# UNITED STATES PATENT AND TRADEMARK OFFICE

10/551,141

<b>Office Action Summary</b>	<b>Application No.</b> 10/551,141	<b>Applicant(s)</b> KARLSSON, DENNIS	
	<b>Examiner</b> Syed A. Islam	<b>Art Unit</b> 3611

## **DETAILED ACTION**

Figure A

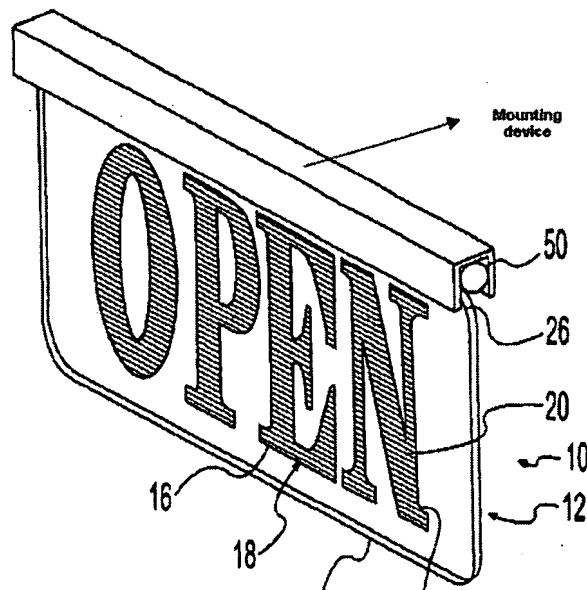
Regarding claim 23, Bradford disclose a first mounting device, that is adapted to position and/or protect light-emitting elements at or inside an edge portion of said electric sign. (see figure A below).

Regarding claim 24, Bradford discloses said mounting device is a continuous element that is arranged along a main part of said edge portion (see figure A where is shows the mounting device is one element).

Regarding claim 27, Bradford as modified discloses said mounting device is provided with at least two connecting means, arranged at different angles in relation to each other. The two side walls of the mounting device can be used as connecting means to connect with a wall or other connectors (see figure A above).

Regarding claim 28, Bradford discloses said mounting device is provided with at least two connecting means displaced by  $90^{\circ}$  (see figure A above).
